RS-15-221

LaSalle County Station, Units 1 and 2
Facility Operating License Nos. NPF-11 and NPF-18
NRC Docket Nos. 50-373 and 50-374

Subject: Revisions to LaSalle County Station, Units 1 and 2, License Renewal Application, Applicant's Environmental Report – Operating License Renewal Stage

**LaSalle County Station, Units 1 and 2
Revisions to License Renewal Application,
Applicant's Environmental Report – Operating License Renewal Stage**

Figure 2.2-1 LSCS Site Layout

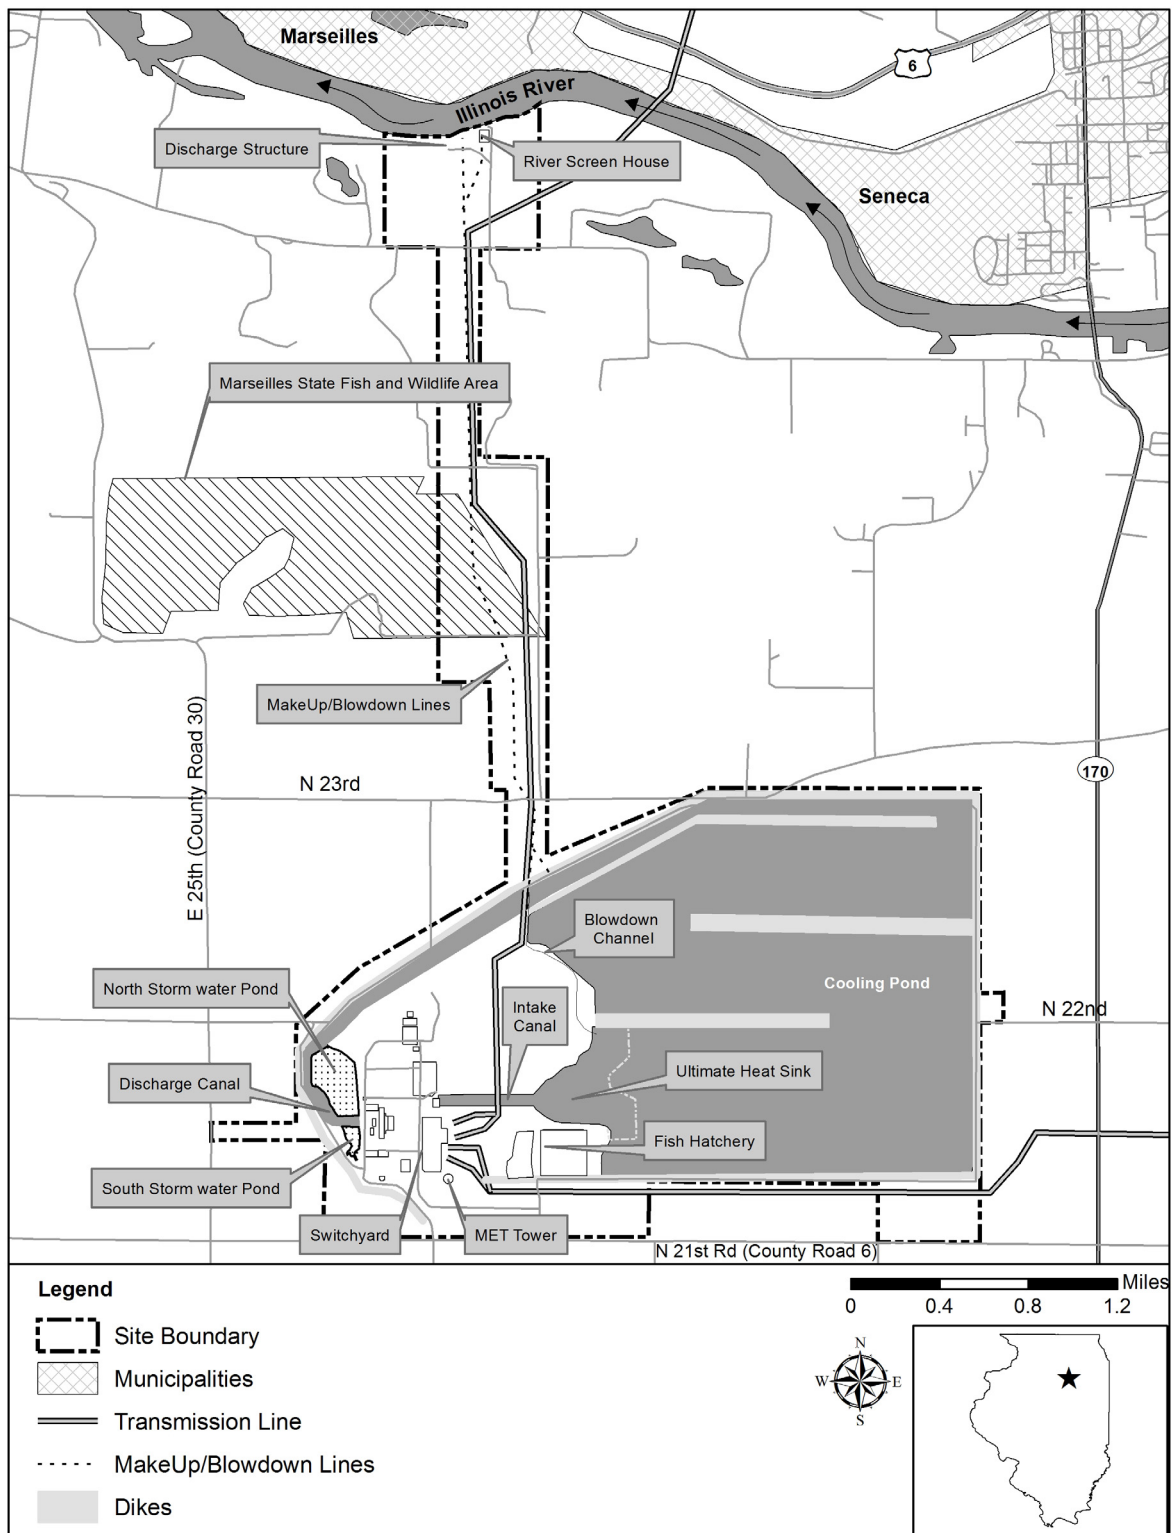
ER-LR Page #	ER-LR Section #	Description of Revision	Purpose of Revision
Cover page	Not applicable	Added ER-LR revision number and changed document date to July 2015	To provide updated document information.
2-5	2.2	Revised Figure 2.2-1, LSCS Site Layout	To correct the location of LSCS property ownership boundaries.
2-6	2.2	Revised Figure 2.2-2, LSCS Plant Layout	To correct the location of LSCS property ownership boundaries.
3-2	3.1	In 2 nd paragraph, 1 st line on the page, changed LSCS total land area from 1,568 ha (3,875 ac) to 1,528 ha (3,776 ac)	To revise the total land area value within the corrected LSCS property ownership boundaries.
3-4	3.2	Revised Figure 3.1-2, 6 Mile (10 km) Radius Map	To correct the location of LSCS property ownership boundaries.
3-5	3.2	In 1 st paragraph, 10 th line on page, updated the reference citation for the National Land Cover Database (NLCD), to the 2011 version of the NLCD (i.e., NLCD 2012)	To clarify that land areas occupied by land use types within the corrected LSCS property ownership boundaries, as presented in Table 3.2-1, have been updated using the 2011 version of the NLCD.

Figure 3.2-1 Land Use 6-Mile Map

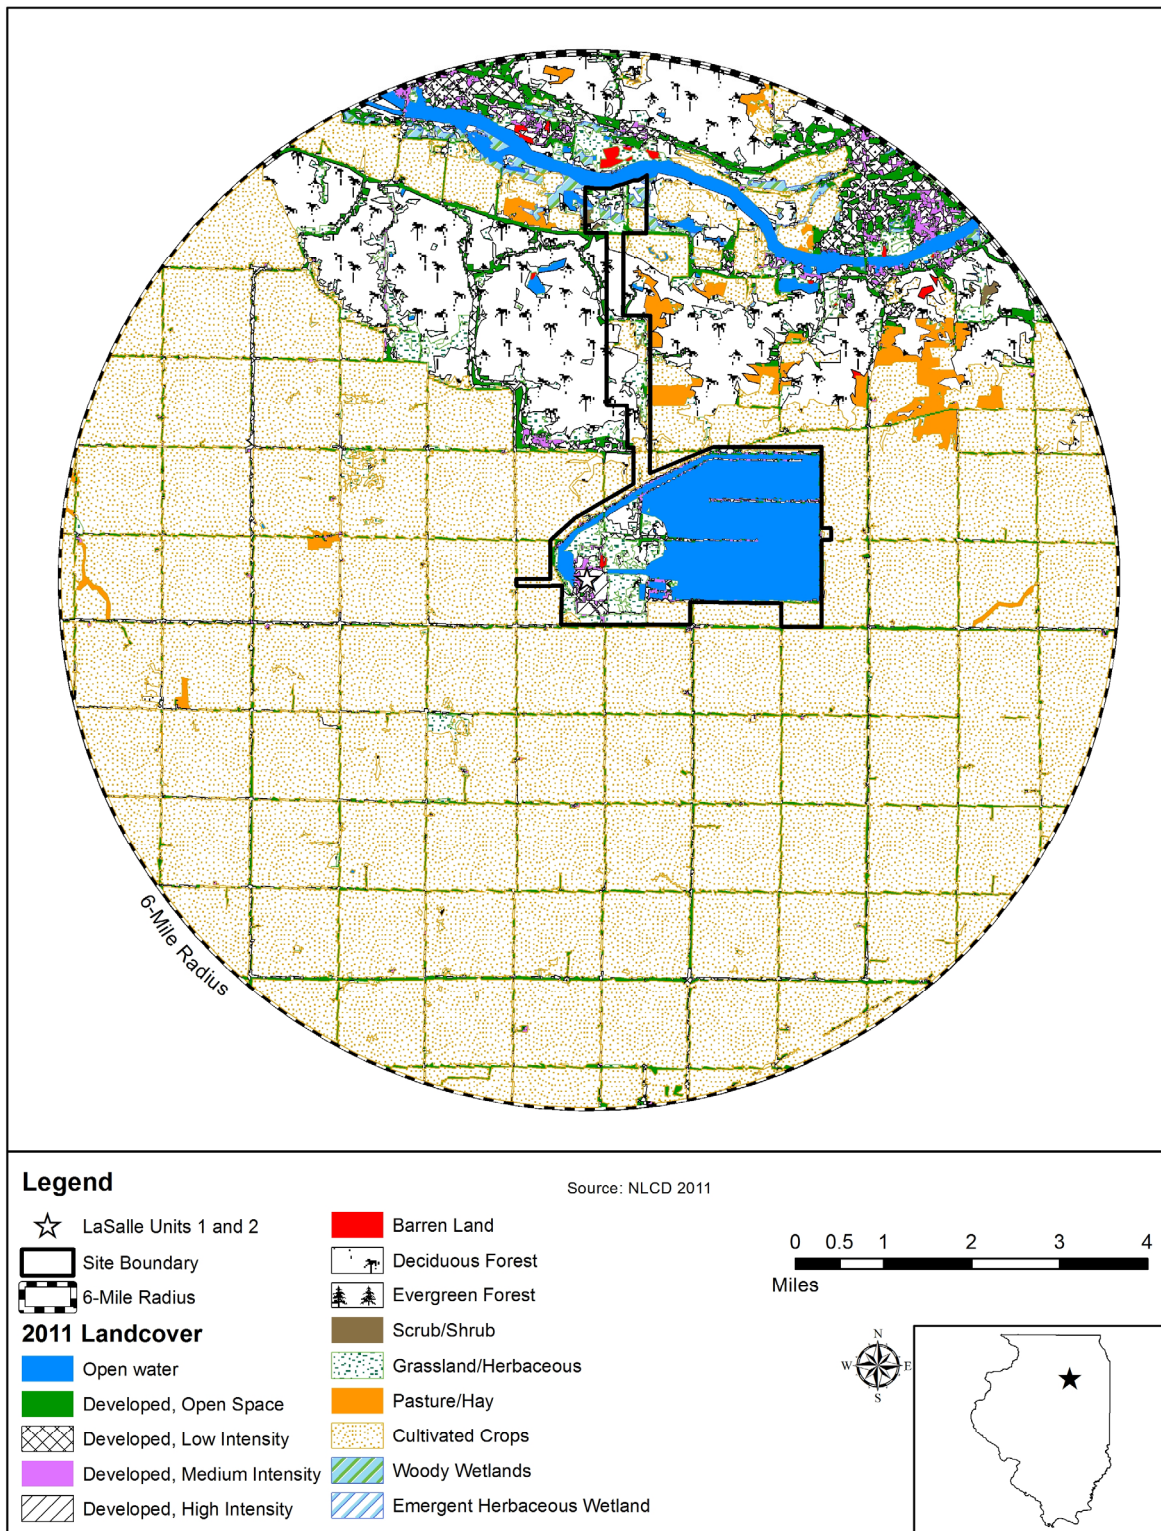
ER-LR Page #	ER-LR Section #	Description of Revision	Purpose of Revision
		LSCS land area occupied by undeveloped acreage from 101 ha (250 ac) to 142 ha (350 ac)	
3-7	3.2	Revised Figure 3.2-1, Land Use 6-Mile Map	To correct the location of LSCS property ownership boundaries and update areas depicted for land cover types to be consistent with the 2011 NLCD.
3-8	3.2	Revised Figure 3.2-2, Land Use - Site	To correct the location of LSCS property ownership boundaries and update areas depicted for land use types to be consistent with the 2011 NLCD.
3-11	3.2	Revised Table 3.2-1, Land Use in the 10-km (6-mi) Radius of LSCS	To revise the values for land areas occupied by specific land cover types within the corrected LSCS property ownership boundaries.
3-18	3.4	Revised Section 3.4, Noise	To more accurately describe applicable state noise control standards as well as current ambient noise sources in the vicinity of LSCS.

Figure 3.5-2 Agricultural Soil Characterization Map

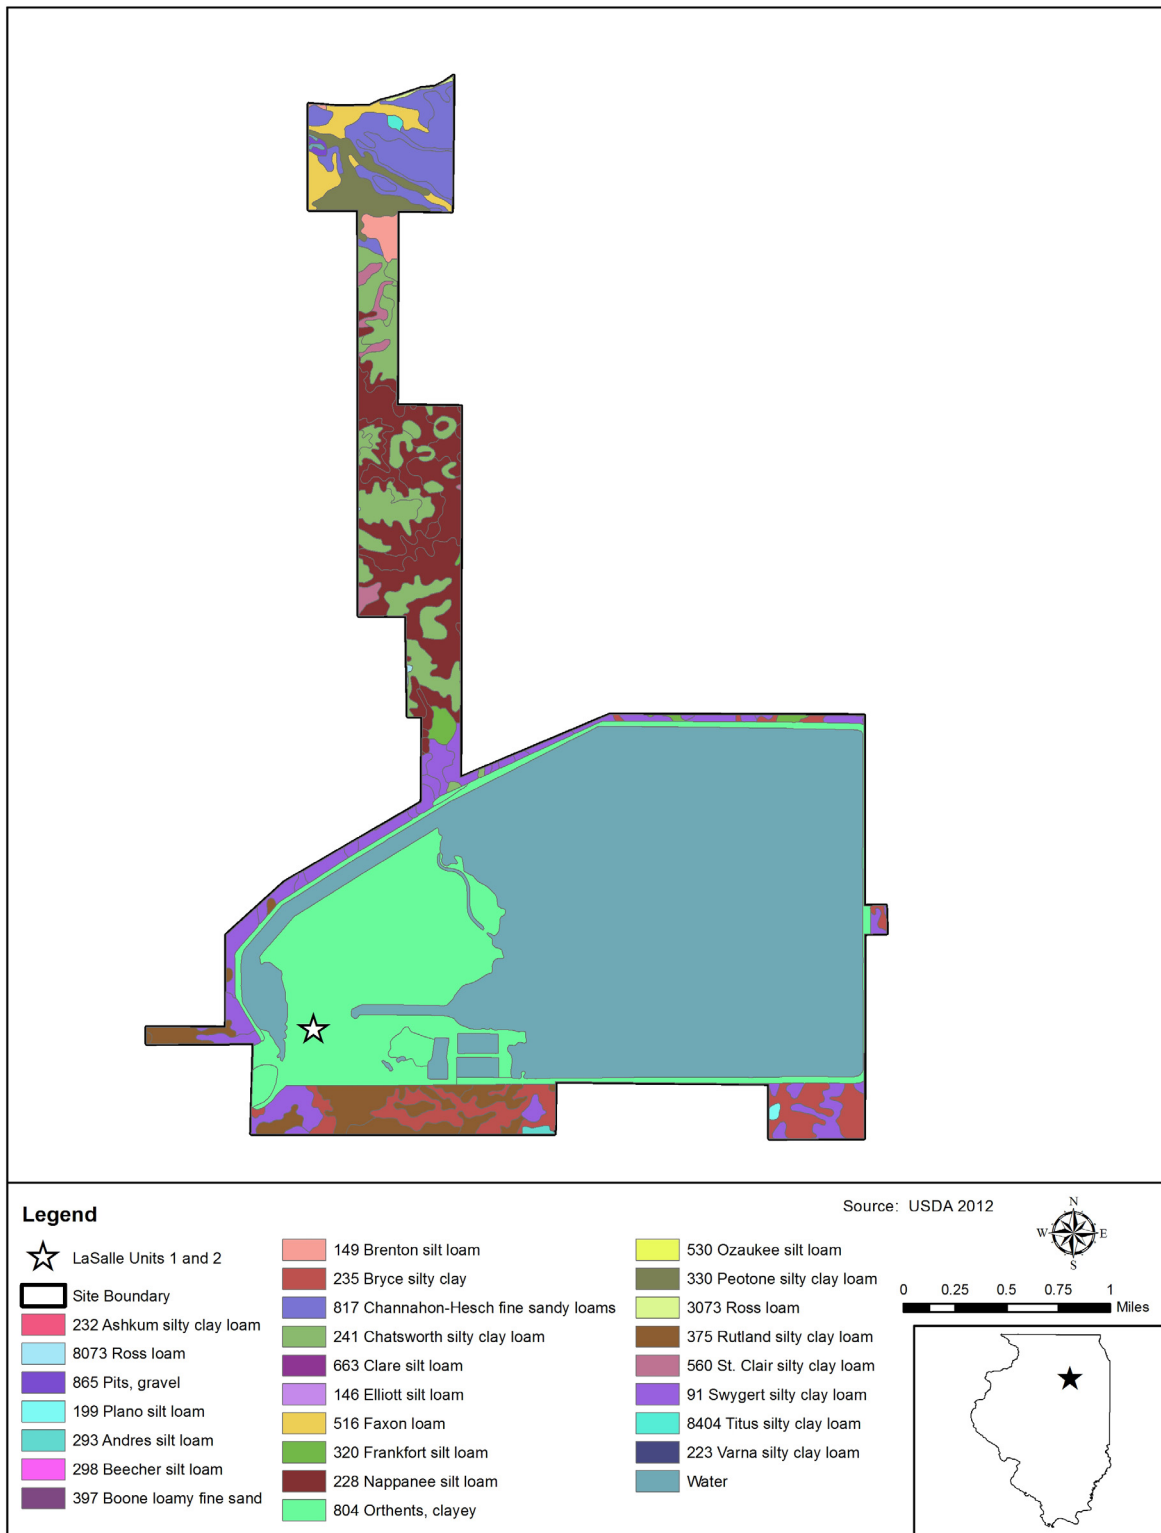
3-24	3.5	Revised Figure 3.5-2, Agricultural Soil Characterization Map	To correct the location of LSCS property ownership boundaries.
3-32	3.6	Revised Figure 3.6-1, Surface Water and Groundwater Well Locations at LSCS	To correct the location of LSCS property ownership boundaries.
3-35	3.6	Revised Figure 3.6-2, Groundwater Flow Map	To correct the location of property LSCS ownership boundaries.
3-48	3.6	Revised Table 3.6-3, Wells within a 1-mi (1.6-km) Radius of LSCS, by changing the entry in the "Well Depth" column for row "8" in the "Well Id" column from "235 (7700)" to "235 (770) "	To correct a typographical error.
3-50	3.7	In 1 st paragraph, 1 st line on page, changed LSCS total land area from 1,568 ha (3,875 ac) to 1,528 ha (3,776 ac)	To revise the total land area values within the corrected LSCS property ownership boundaries.
3-61	3.7.1.7	Revised Section 3.7.1.7, Special Status Aquatic Species	To acknowledge the changed regulatory status of the American eel, which was listed as threatened in May 2015 by the Illinois Department of Natural
